Access Compliance Report

Public Rights-of-Way

(Curb Ramps)

Intersection ID: 45281	Main Street: CIERA_NICHOLE_CT	Cross Street: LAKEHILL_RD	Location: S
ADA ID: 4E581440C850	Ramp Type: PerpDiag	Initial Pass/Fail: Fail	Overall Compliance: No
Codes/Mitigation Info/Possible Solution		Field Measurements/Component Compliance	
Severity Score: 37.5

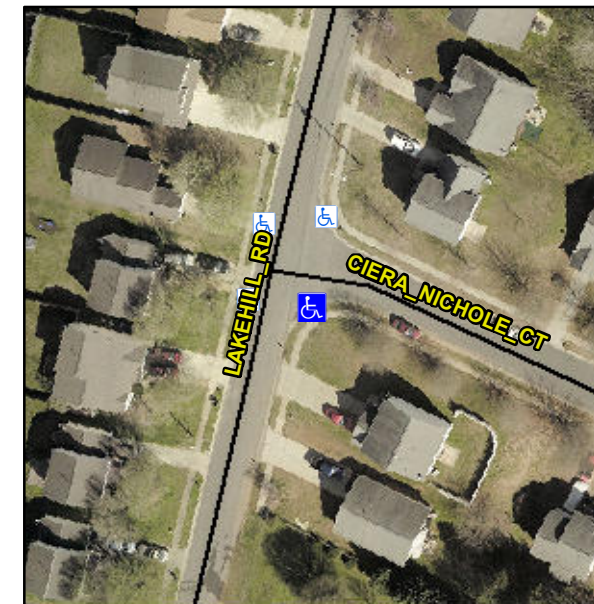
R304.2.2, R304.5.3

Compliance	Description	Data	Compliance	Description	Data
N/A	Ramp Length (in)	48.5	No	Ramp Slope (%)	8.9
Yes	Ramp Width (in)	48.5	No	Ramp XSlope (%)	9.2
N/A	Flare Type LT	N/A	N/A	Flare Type RT	N/A
N/A	Flare Slope LT (%)	N/A	N/A	Flare Slope RT (%)	N/A
N/A	Flare Traversable LT?	N/A	N/A	Flare Traversable RT?	N/A
N/A	Landing Length (in)	N/A	N/A	DWS Provided?	N/A
N/A	Landing Width (in)	N/A	N/A	DWS Contrast?	N/A
N/A	Landing Slope (%)	N/A	N/A	DWS Length (in)	N/A
N/A	Landing X Slope (%)	N/A	N/A	DWS Full Width?	N/A
N/A	Landing Curb? (Y/N)	N/A	N/A	DWS Offset (in)	N/A
N/A	Shared Landing?	N/A			
N/A	Gutter Ponding?	N/A	N/A	Gutter Slope (%)	N/A
N/A	Gutter Lip Ht (in)	N/A	N/A	Gutter X Slope (%)	N/A
N/A	Painted X Walk1?	No	N/A	Painted X Walk2?	No
	X Walk 1 Direction	To NE		X Walk 2 Direction	To NW
N/A	X Walk 1 Width (in)	N/A	N/A	X Walk 2 Width (in)	N/A
	X Walk 1 Slope (%)	2.1		X Walk 2 Slope (%)	11.5
	X Walk 1 X Slope (%)	11.1		X Walk 2 X Slope (%)	0.7

N/A	Ramp inside XWalk1?	N/A	N/A	Ramp inside XWalk2?	N/A
	Road Slope (%)	8.2	N/A	Clear Space?	N/A
	Road X Slope (%)	8.5	N/A	Clear Space to XWalk (in)	N/A
N/A	Any Obstructions?	N/A	N/A	Storm Grate/Utility Hazard?	N/A
	Obstruction Type			Storm Grate/Utility Type	
		N/A			N/A
			Yes	Surface Condition? (G/P)	Good

Remove & Replace Curb Ramp With Two New Directional Ramps or Equivalent.
